BP - San Juan Wellwork Procedure Plug & Abandonment

HEATON LS 014-DK
30-045-10351-00

Re: Permanent Abandonment
Well: 14 Heaton LS

CONDITIONS OF APPROVAL

Proposed Wellbore Diagram

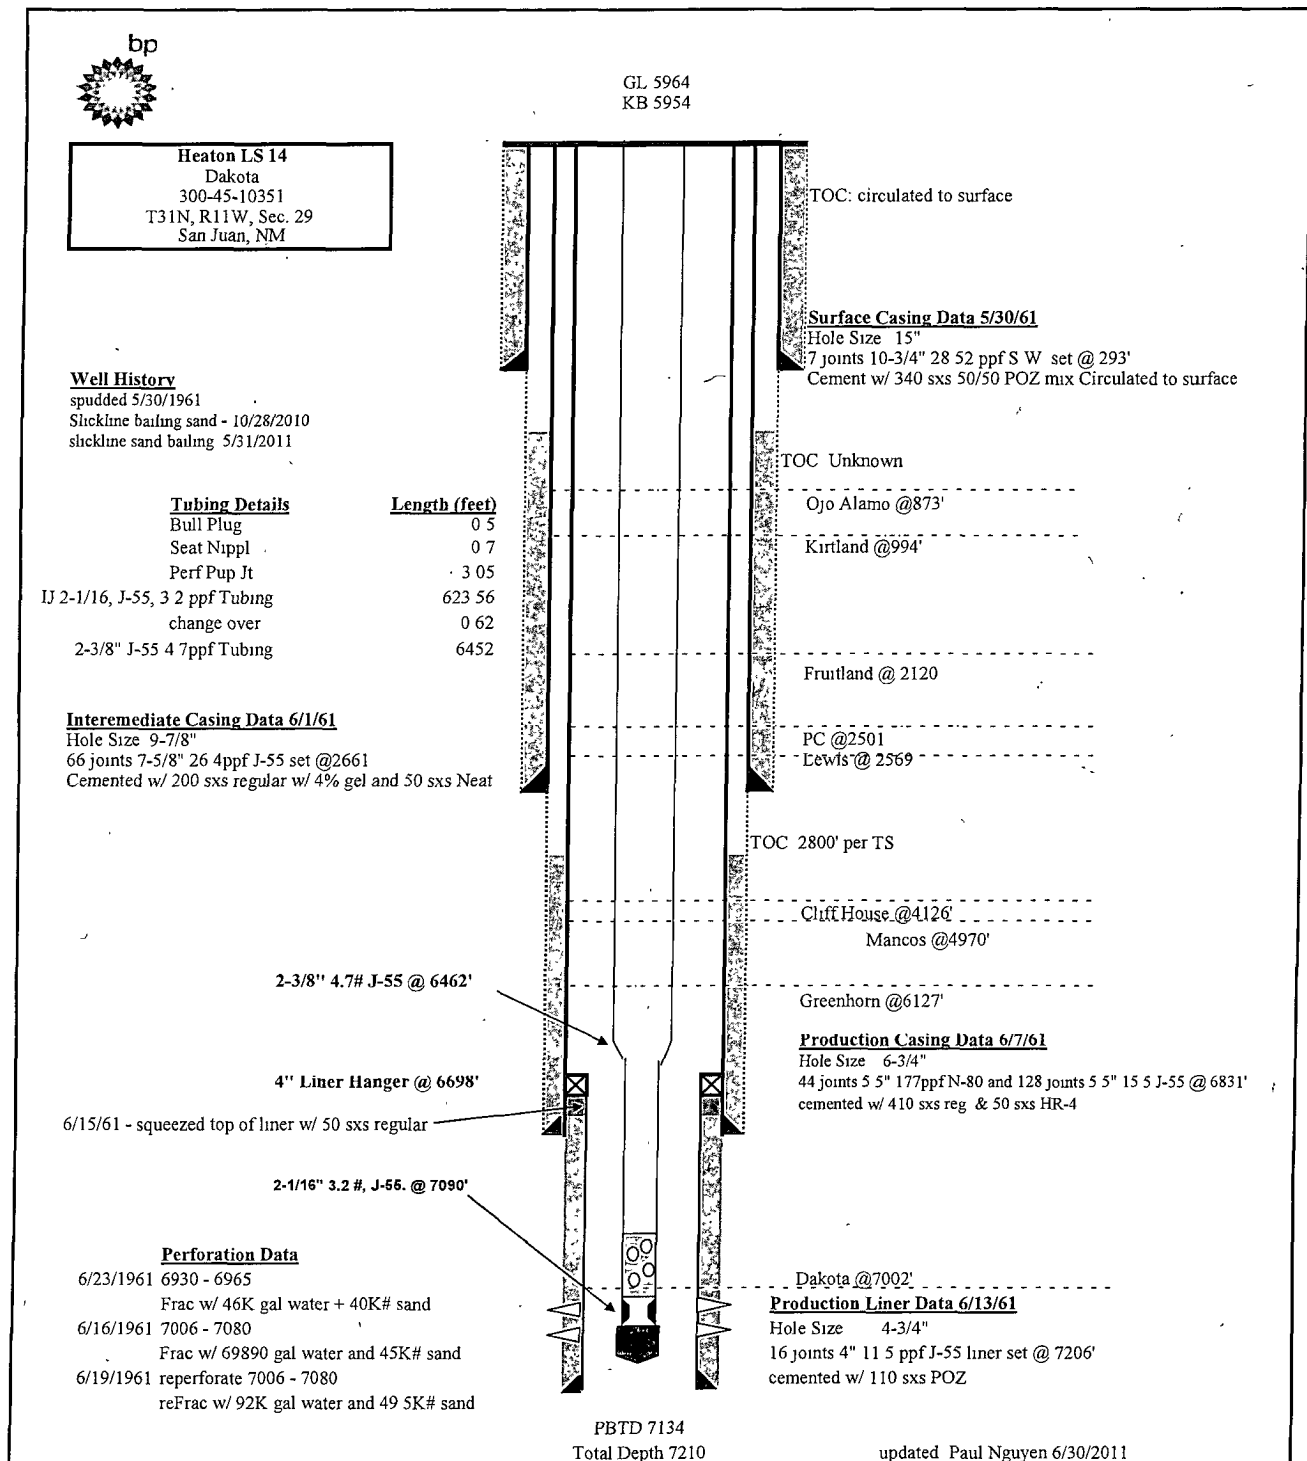
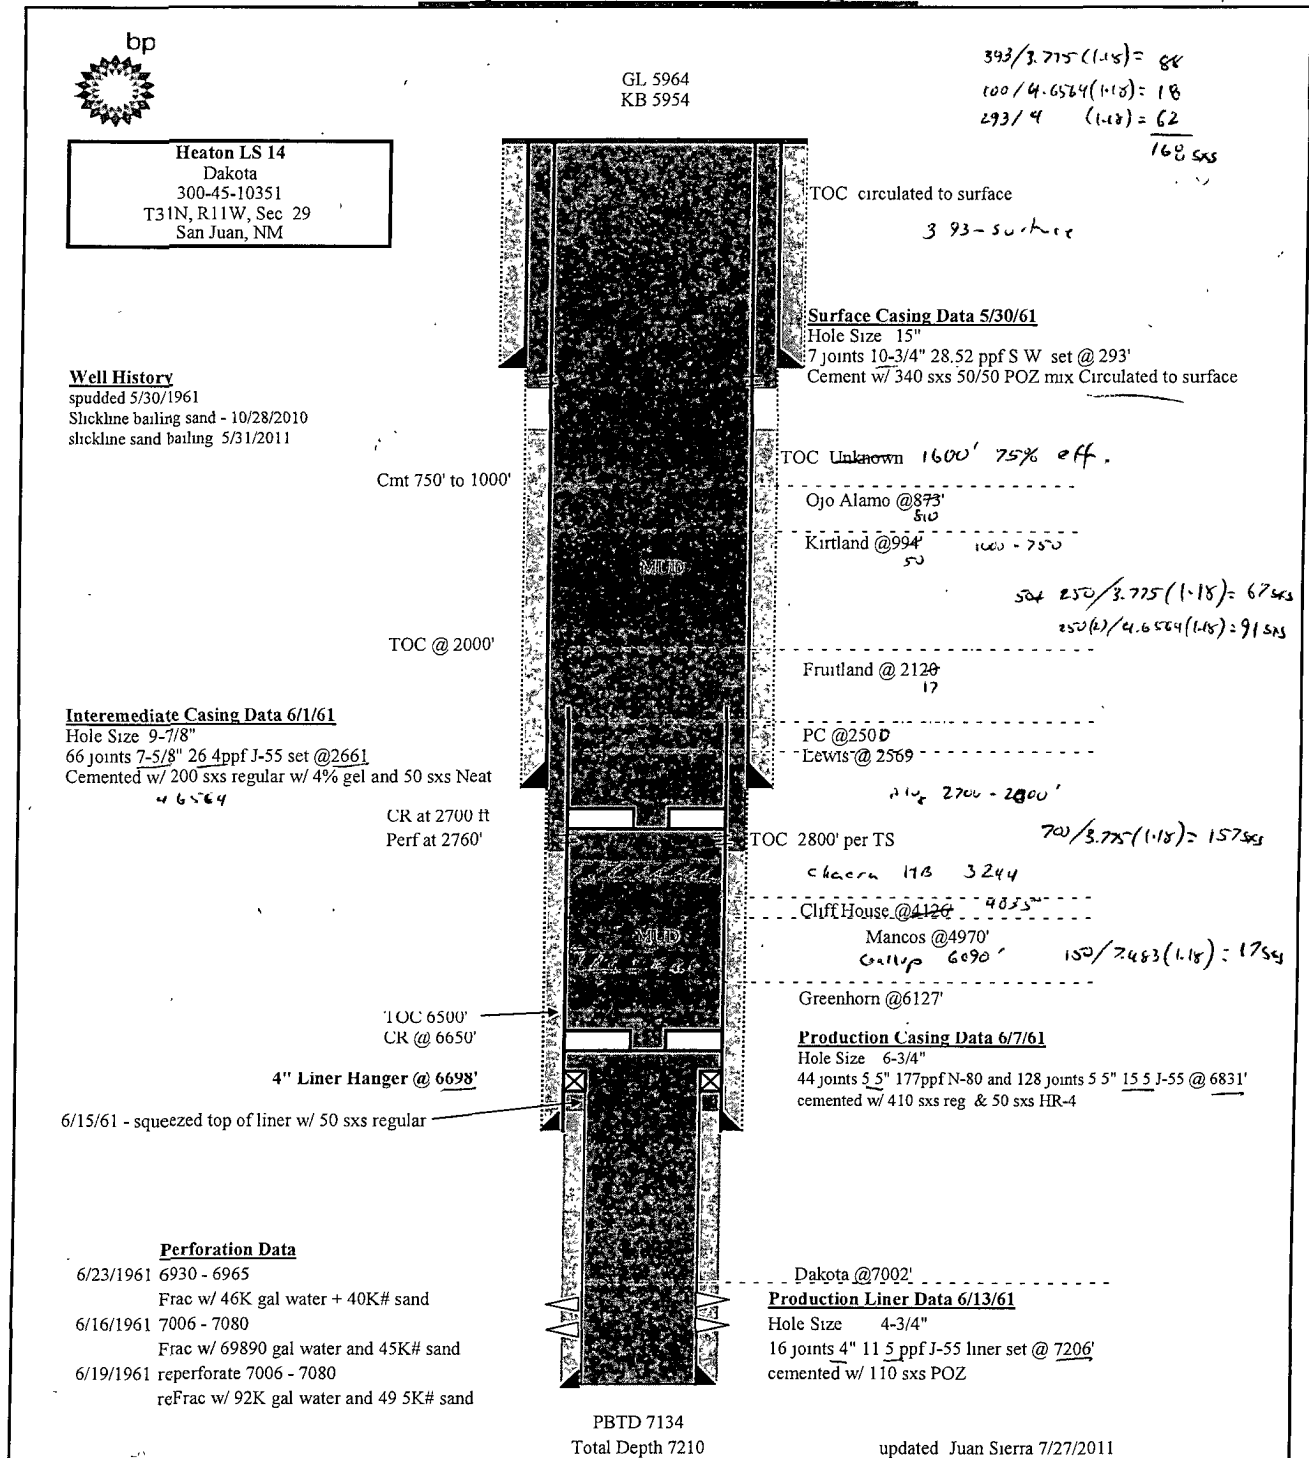
plug Gallup from 6140' - 6040'
plug Chacra from 3294' - 3194'

1. Plugging operations authorized are subject to the attached "General Requirements for Permanent Abandonment of Wells on Federal and Indian Lease."
2. Farmington Office is to be notified at least 24 hours before the plugging operations commence (505) 599-8907.
3. The following modifications to your plugging program are to be made:
 - a) Place a cement plug from 6140' – 6040' to cover the Gallup top.
 - b) Place the Mesaverde (Chacra Equivalent) plug from 3294' – 3194'.

You are also required to place cement excesses per 4.2 and 4.4 of the attached General Requirements.
